Pentium® Processor Specification Update

Release Date: August, 1997

Order Number: 242480-029

The Pentium® processor may contain design defects or errors known as errata which may cause the product to deviate from published specifications. Current characterized errata are documented in this Specification Update.

2. **Incorrect TCP Pinout Drawing**

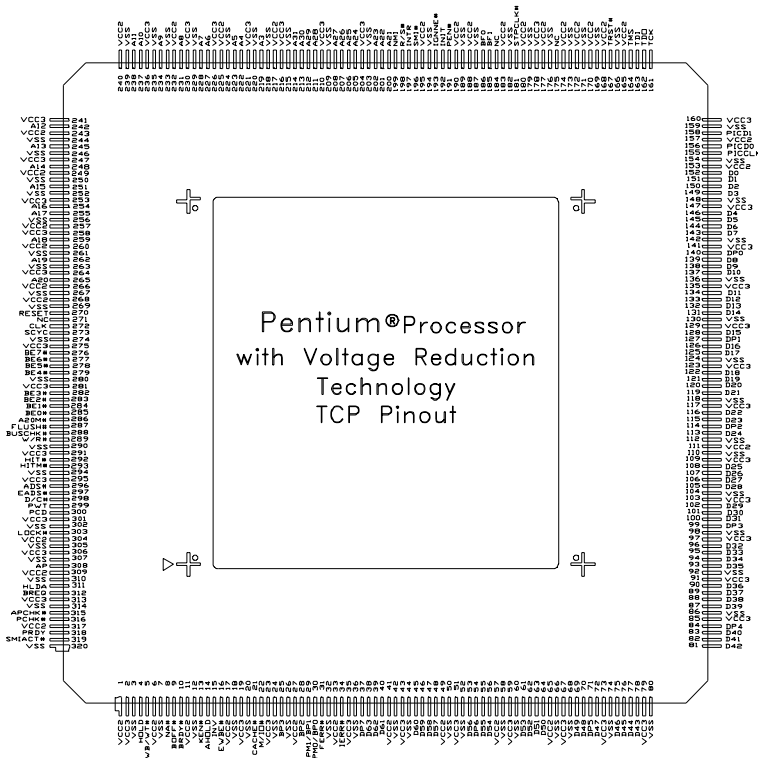
The TCP pinout drawing on page 8 of the *Pentium Processor with Voltage Reduction Technology* datasheet was inadvertently rotated. The correct orientation is shown below.

Figure14-1. Maximum Undershoot Level, Undershoot Threshold Level, and Undershoot Threshold Duration

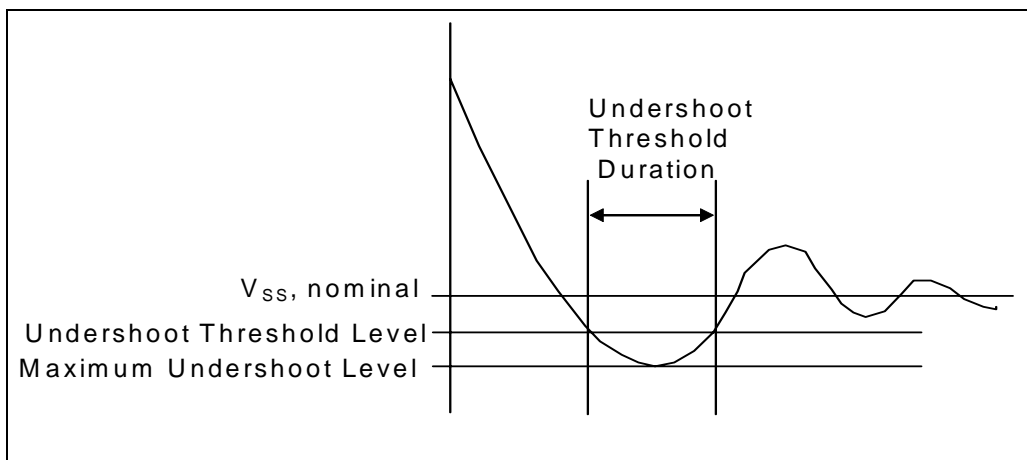
MAXIMUM RINGBACK SPECIFICATION: The maximum ringback of CLK associated with its low state (undershoot) must not exceed 0.8V as shown in Figure 14-1.

MAXIMUM UNDERSHOOT AND MAXIMUM RINGBACK SPECIFICATIONS: The display should show continuous sampling (e.g., infinite persistence) of the waveform at 500 mV/div and 5 ns/div (for CLK) for a recommended duration of approximately five seconds. Adjust the vertical position to measure the maximum undershoot and associated ringback. There is no allowance for crossing the maximum undershoot or maximum ringback specifications.

UNDERSHOOT THRESHOLD DURATION SPECIFICATION: A snapshot of the clock signal should be taken at 500 mV/div and 500 pS/div (for CLK). Adjust the vertical position and horizontal offset position to view the threshold duration. The undershoot threshold duration is defined as the sum of all time during which the clock signal is below -0.5V within a single clock period. The undershoot threshold duration must not exceed 20% of the period.

This undershoot specifications are illustrated graphically in Figure 14-1 and Figure 14-2.
